LETTER OF TRANSMITTAL

DATE: July 22, 1998

SUBJ: Drainage Plan for Blanchat Machine Addition

DRAINAGE PLAN FOR BLANCHAT MACHINE COMPANY ADDITION

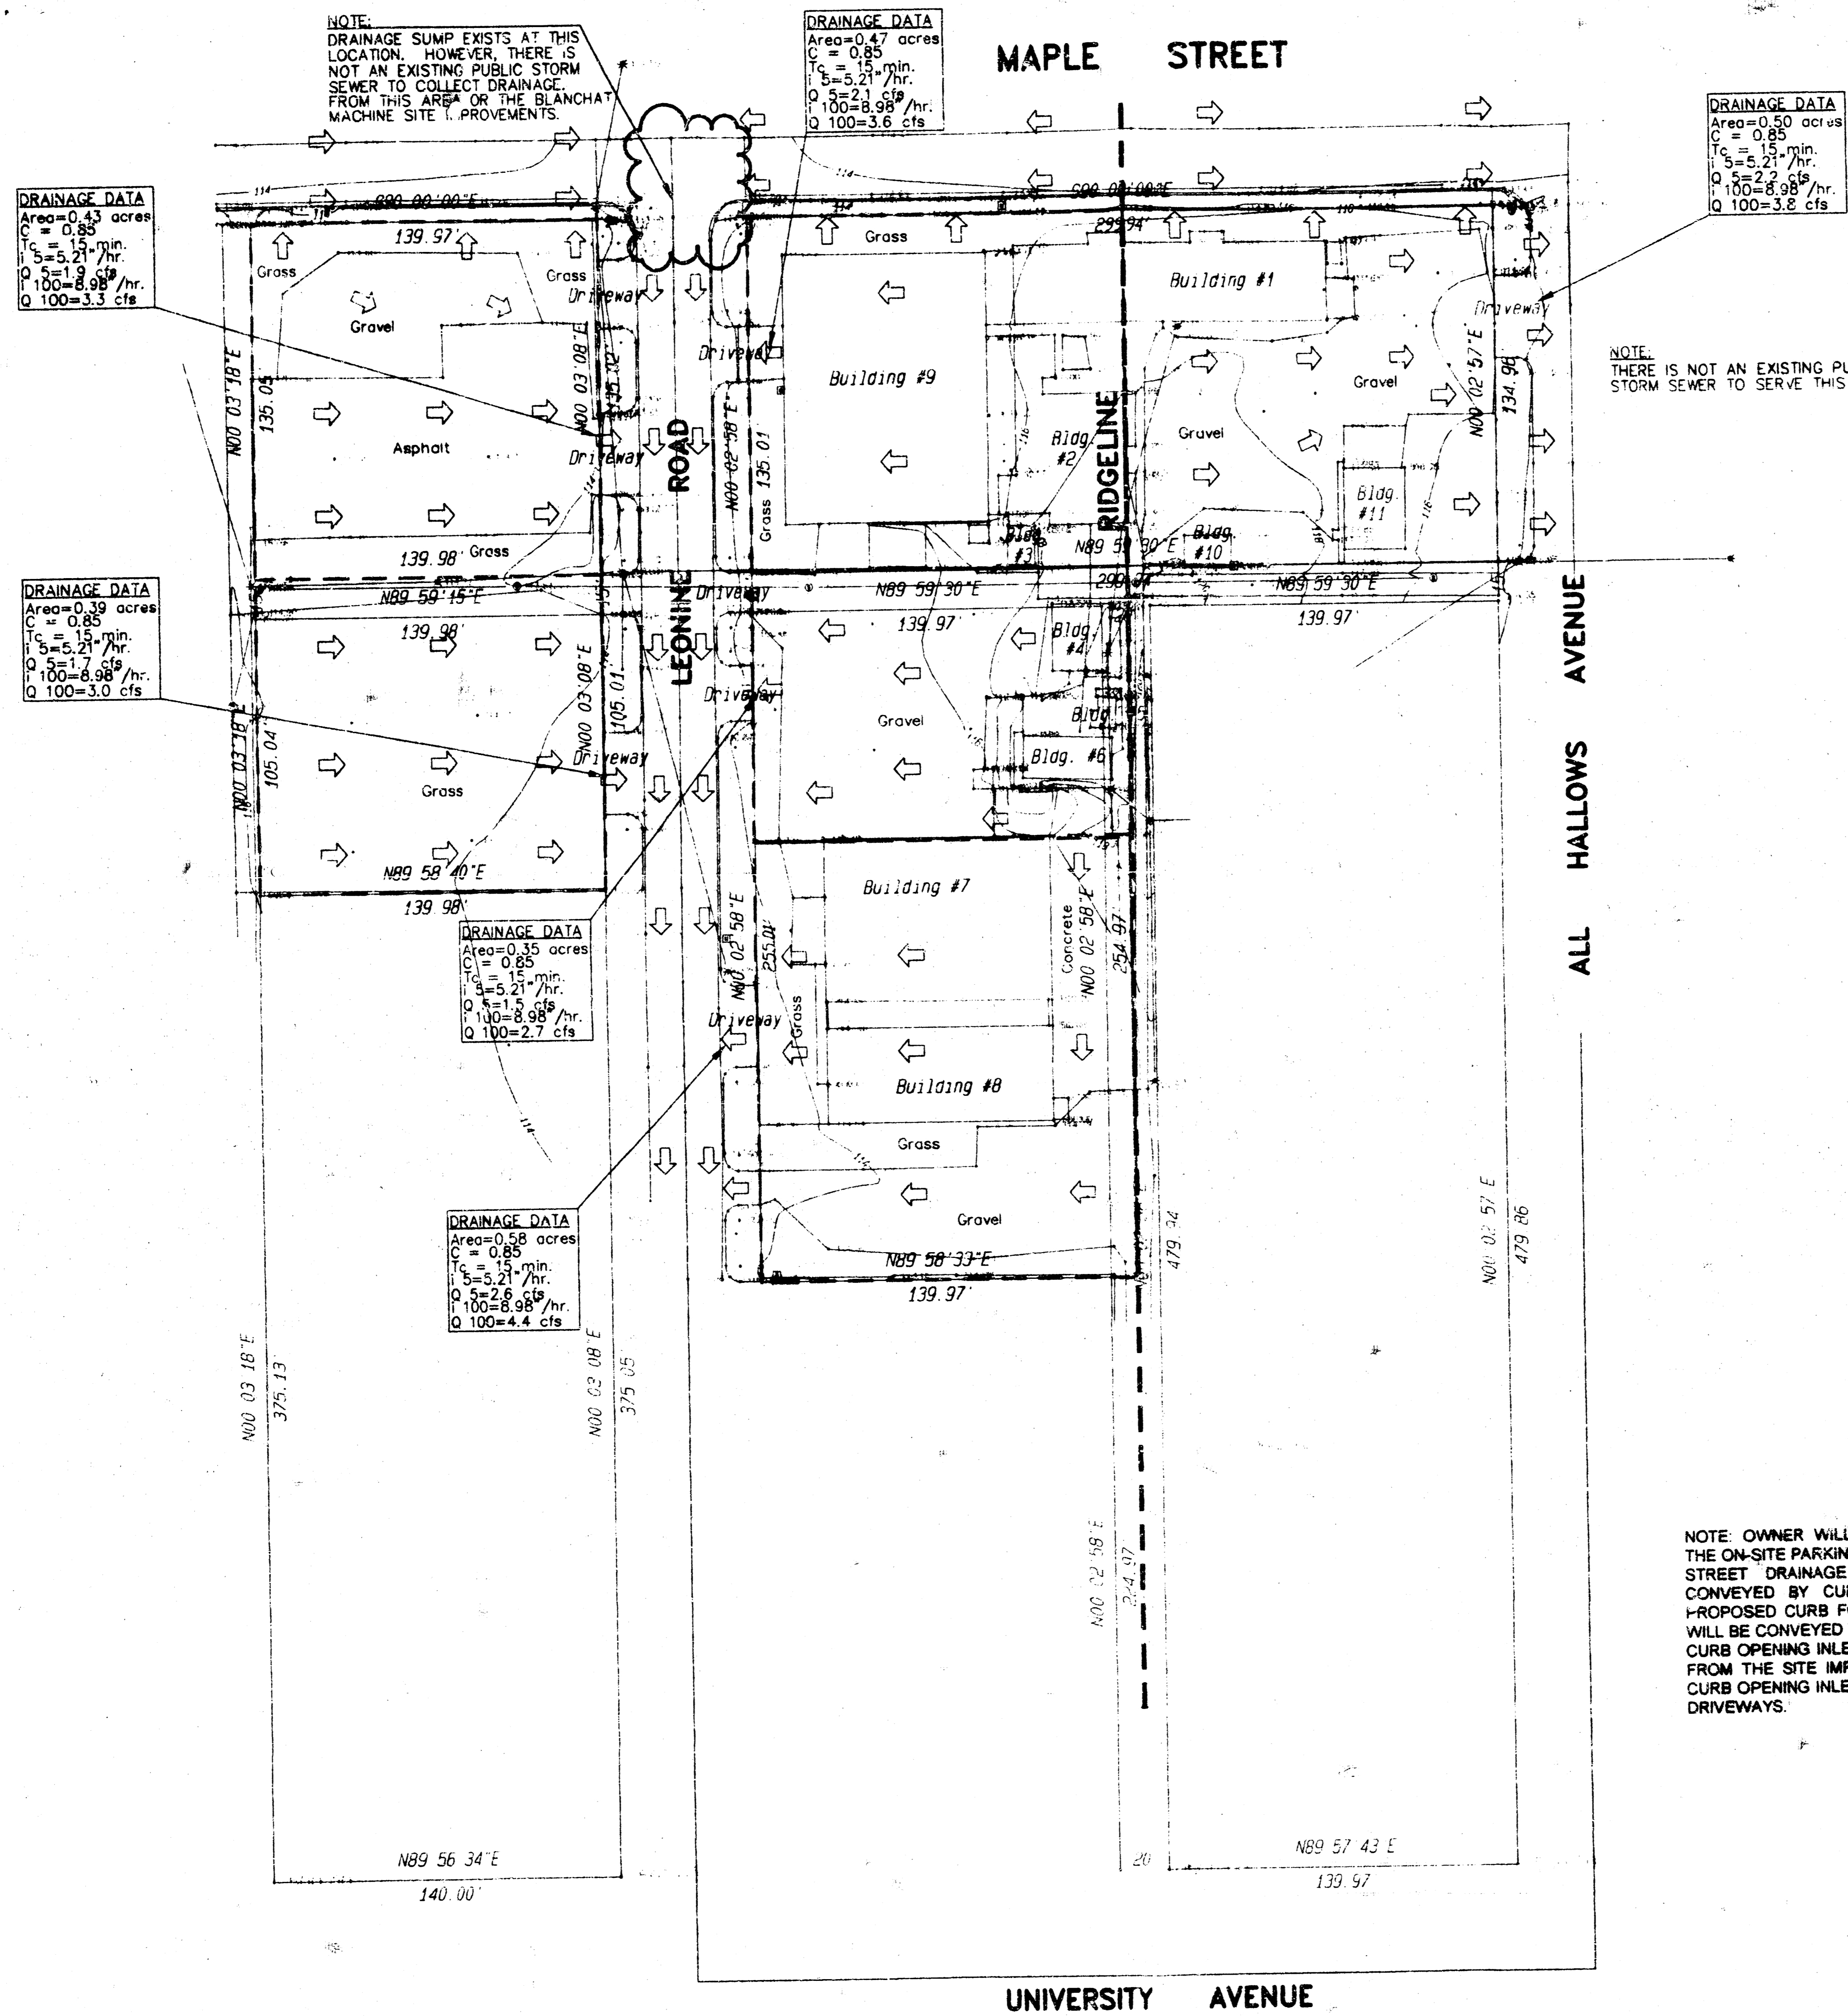
COMMENTS: Attached find the revised drainage plan for the above referenced addition. A note has been added to the drainage plan requiring on-site parking lot detention will be required when the site improvements are constructed.

NOTE: OWNER WILL IMPLEMENT DETENTION STORAGE INTO THE ON-SITE PARKING LOTS AND WILL RESTRICT FLOW TO THE STREET DRAINAGE SYSTEM TO THAT WHICH WILL BE CONVEYED BY CURB OPENING INLETS LOCATED IN THE PROPOSED CURB FOR THE ON-SITE PARKING LOT. RUNOFF WILL BE CONVEYED TO THE STREET CURB VIA 6" PVC PIPE AND CURB OPENING INLETS IN THE STREET CURB. THE DRAINAGE FROM THE SITE IMPROVEMENTS WILL BE DIRECTED TO THE CURB OPENING INLETS AND WILL NOT BE CONVEYED OUT THE DRIVEWAYS.
